RISK REDUCTION FEASIBILITY STUDY
OF SELECTED MODIFICATIONS TO
CRBRP SAFETY SYSTEMS

FINAL REPORT

SAI-84-123-WA

U.S. Nuclear Regulatory Commission
Washington, D.C. 20555

Figure 3-2. (CONTINUED)

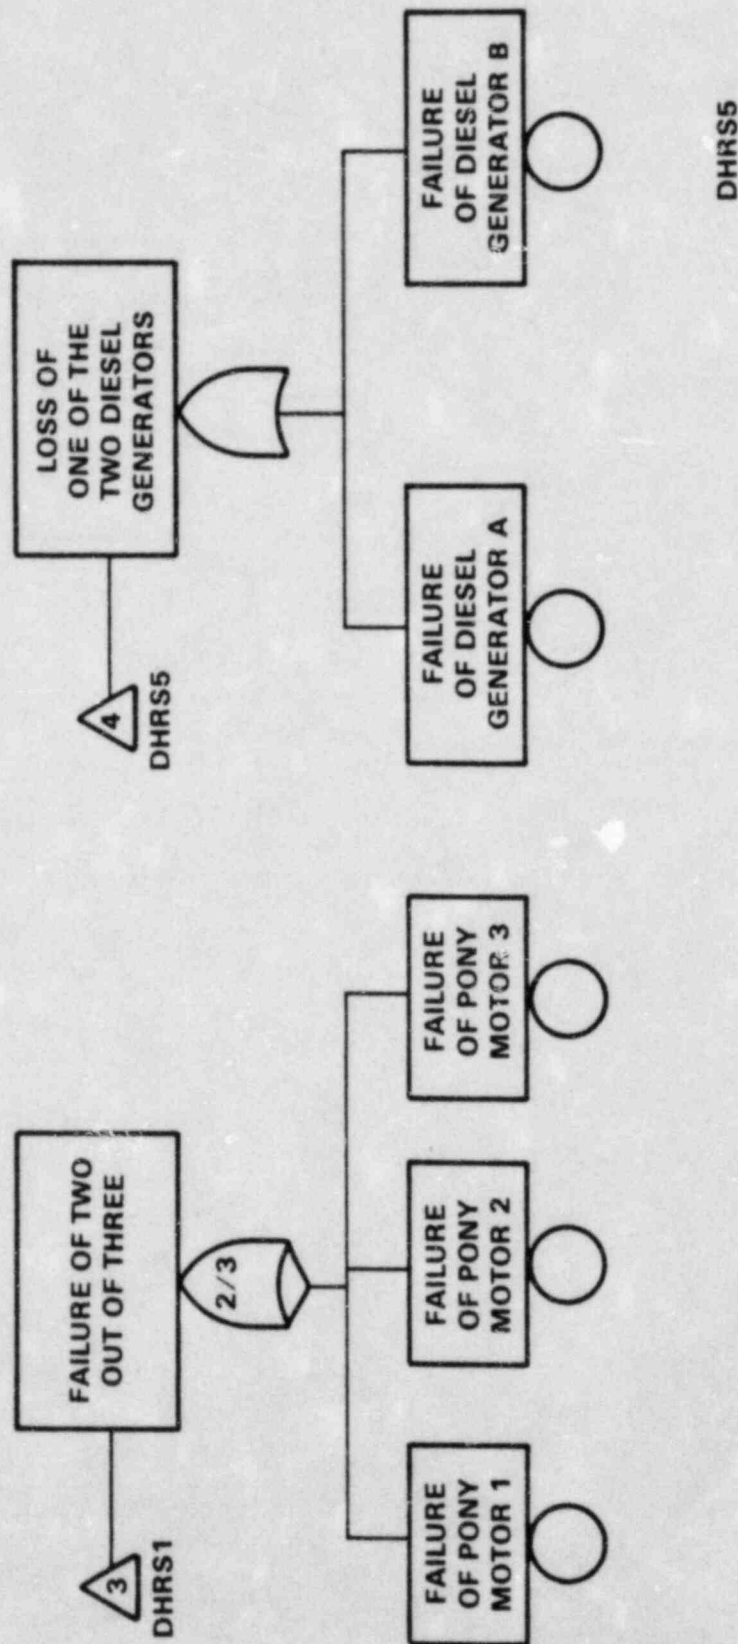
As can be seen from the table the failure probability of the DHRS is dominated by failure of any one of seven valves to change state and one NaK pump to start. This is because neither the primary system nor the secondary system is redundant initially, i.e., all the valves and the pump failures are single element minimal cut sets. As was mentioned earlier, after a period of operation of DHRS (approximately 30 hours) the decay heat is reduced to the point where only operation of one secondary loop is necessary. With respect to the question of possible need for a diverse source of AC power to the DHRS it is clear from the table that the contribution of failure of the electric power to the failure of the DHRS is very small. This is due to the fact that the DHRS is only required when all three primary heat transport loops are lost. Thus if the accident initiator is the loss of all three main heat transport loops where DHRS has to remove the decay heat, for the system to be disabled there must be a loss of

Event	Failure Probability	Major Contribution
Failure of DHRS Primary System	1.0×10^{-3}	Failure of SOV 103 to Change State
Failure of DHRS Secondary System	7.0×10^{-3}	Failure of Six SOV's and one NaK Pump to Start
Failure of Two Out of Three Pony Motors	3.0×10^{-8}	
Failure of Electric Power to DHRS	1.6×10^{-5}	
Human Related Error	1.0×10^{-4}	Only Operator Error to Initiate the System is Assumed
DHRS Failure on Demand	8.1×10^{-3}	Failure of Seven SOV's to Change State and One Pump to Start

Figure 4-4. VARIOUS PENETRATION RATES AS A FUNCTION OF TIME

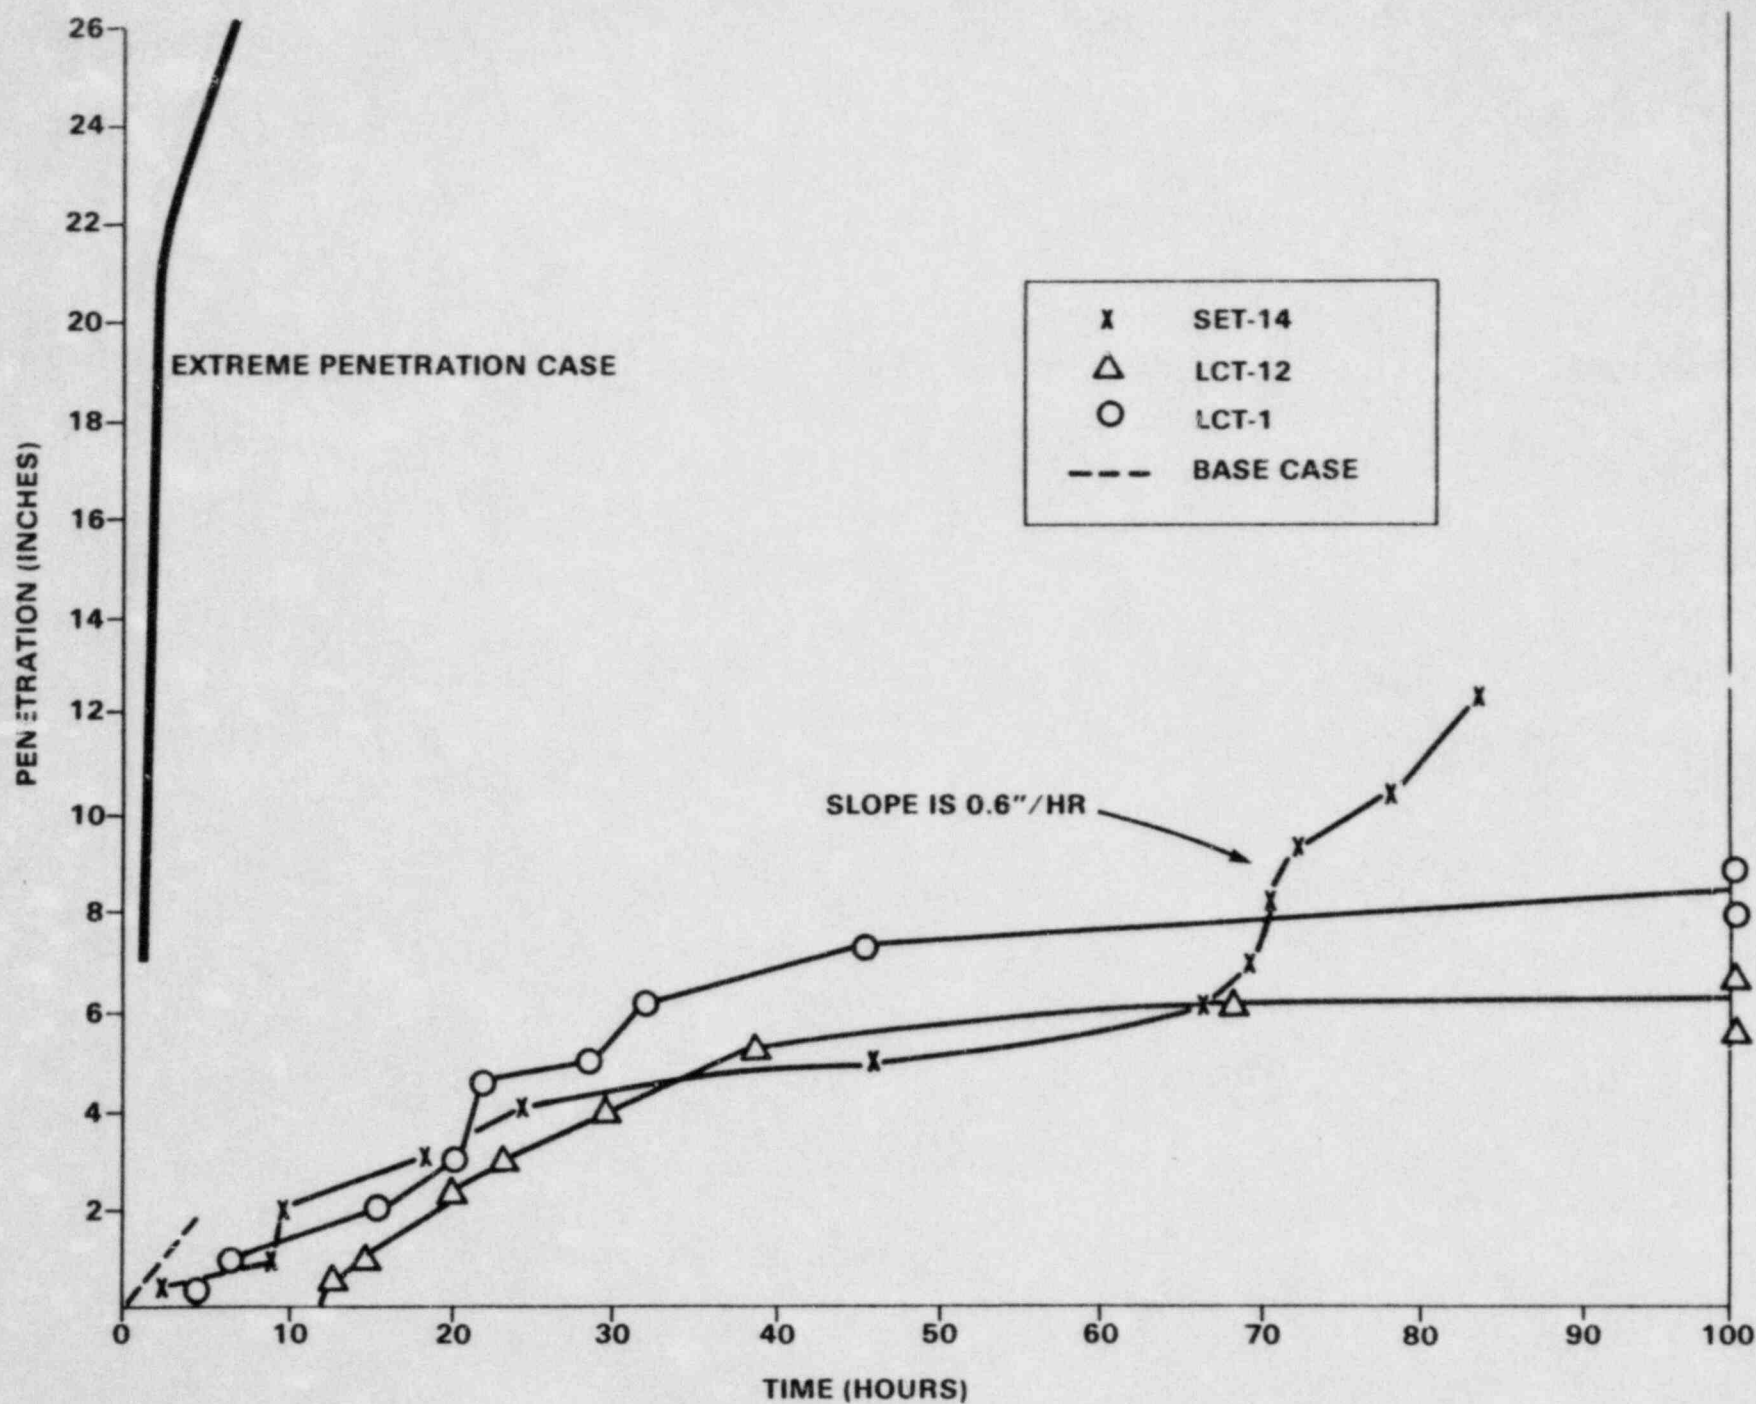
Figure 4-3 shows the results of various sodium concrete interaction experiments (24). Note that the results of the latest HEDL experiments such as SET-14, LCT-13 are also shown on this figure. The most reactive Sandia experiments mentioned earlier are experiments LS-1, LS-2 and LS-3 which were performed for short periods of time due to sodium limitation. Note also that experiments LS-4, LS-5 and LS-8, which are part of the same series of experiments as LS-1 through LS-3, show very small reaction rates and penetration. The highest total penetration of sodium in concrete was observed in the SET-14 experiment. In this experiment a total penetration of approximately 13 inches was observed in about 90 hours. The LCT-2 experiment shown next to SET-14 was based on interaction of sodium and dehydrated concrete. It is also interesting to note that for all the experiments that have been carried out in the range of 20 to 40 hours the maximum penetration is less than 5 inches. Figure 4-4 shows the sodium penetration into concrete as a function of time for experiments SET-14, LCT-1 and LCT-12 which have shown the highest total penetration of sodium in concrete. Also shown on the figure is the assumed penetration rate for the base case (0.5 inches per hour for four hours) and an extreme penetration case which the applicant has analyzed. The extreme penetration case is based on a sodium penetration rate of seven inches per hour for three hours and one inch per hour from three hours on. It is very interesting to note where this extreme penetration rate comes from. Until recently NRC's position on containment response to a core melt down accident has been that following a CDA and guard vessel penetration, the containment integrity must be maintained for a period of 24 hours without venting so that sufficient time would exist for implementation of any evacuation. The applicant has analyzed the extreme penetration case as an upper bound case where if the requirement for time of venting is relaxed to 10 hours then a total of 28

inches of sodium penetration in concrete can be accommodated without containment failure. This total penetration can be found by looking at Figure 4-5 which shows the time to vent vs. total concrete penetration (24). Thus if it is assumed that a venting time of 10 hours is acceptable the total penetration which can be accommodated is 28 inches. The extreme penetration rate of 7 inches per hour for three hours and one inch per hour from there on results in a total penetration of 28 inches in 10 hours. Also the initial rate of 7 inches per hour corresponds to the most reactive SANDIA experiment LS-1 (Figure 4-3) which was performed for approximately 20 minutes. Thus it is extremely important to realize that the extreme penetration case is not based on any observed experimental result and in effect is a backward calculation which shows the total penetration that can be accommodated if a 10 hour venting based on 6% accumulation of hydrogen is assumed. Looking at Figure 4-4, it can be seen that the initial penetration rate assumed for the base case is higher than the experimental results shown but the total penetration for the time period of interest, i.e., 20 to 40 hours is not conservative. Thus it seems that a more realistic base case where the rate and total penetration of sodium is higher than the current base but considerably lower than the extreme penetration case is highly desirable.

Figure 6.4. PREDICTED INLET GAS TEMPERATURES FOR THE POLYPROPYLENE GAS FILTER

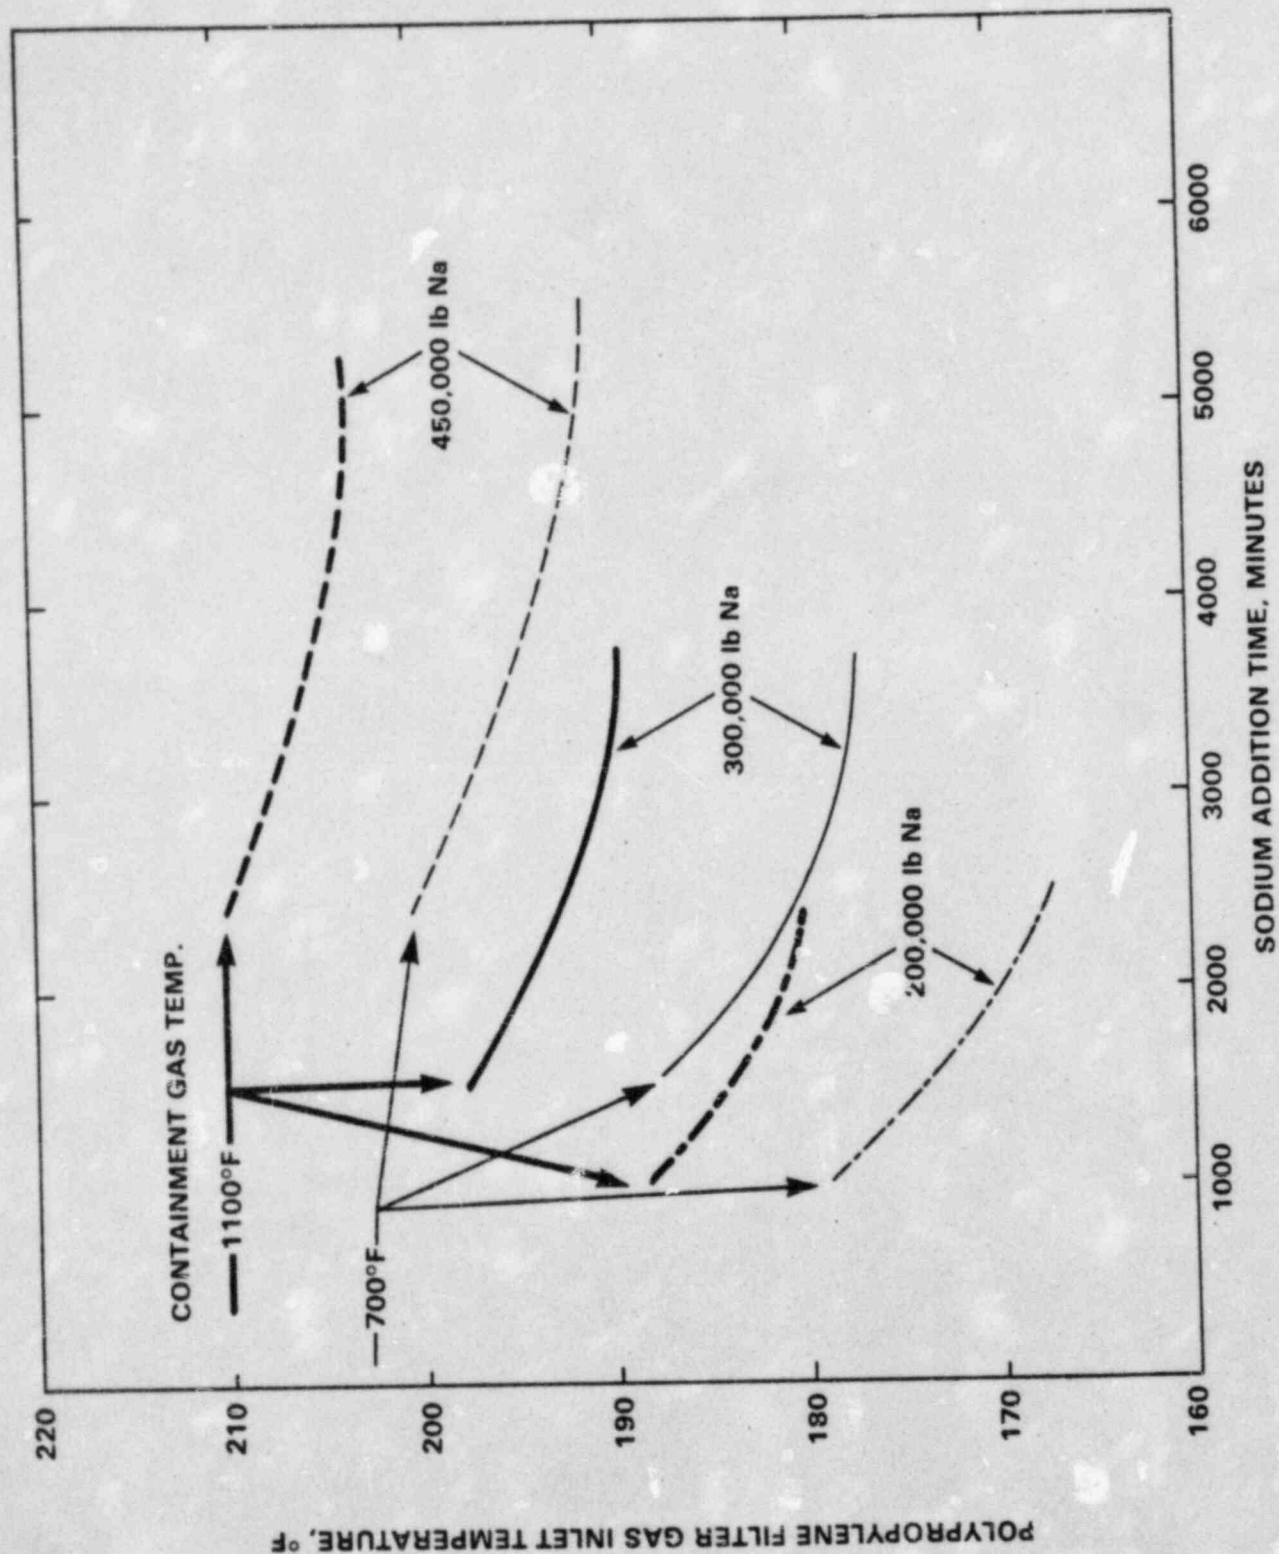
The results of the independent analysis are presented in Figure 6.4. It shows the results of some parametric analysis examining the effect of different inlet gas temperatures, sodium addition times (inversely related to inlet sodium concentration) and total sodium added to the CCS. For reported design conditions (about 300,000 lbs of sodium added and

average gas temperatures less than 1100°F) it does not appear that the 200°F limit will be exceeded although it will be approached, particularly for high inlet sodium concentrations. The figure also shows that greater amounts of sodium entering the CCS could present problems with regard to the 200°F limit.
